TECHNICAL SERVICE BULLETIN TSB-001-2016-11

Subject: AS710R threading hole for pedal wire improvement

SITUATION INVOLVED MACHINES: AS710R

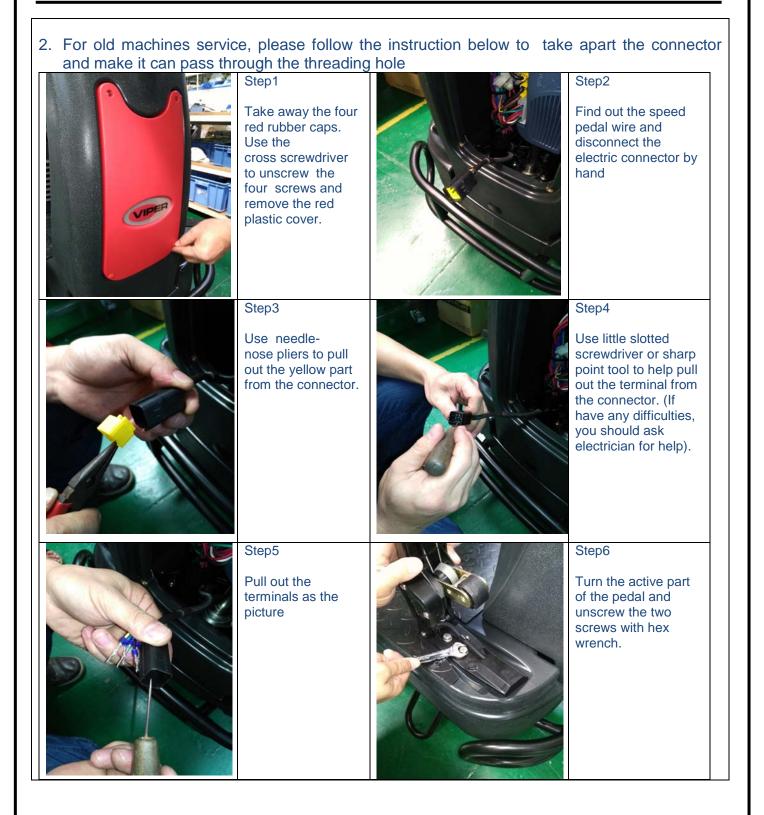
The threading hole is too small.

When replacing the pedal, the connector of the pedal wire cannot pass through the threading hole.

Design issue. The size of the connector is big, but the threading hole is too small. It needs a tool for taking the pins out of the connector, it is to complicate.

1. For new machines: We have changed the threading hole on the tank, made it bigger, now the connector of the pedal wire can pass through the threading hole directly.
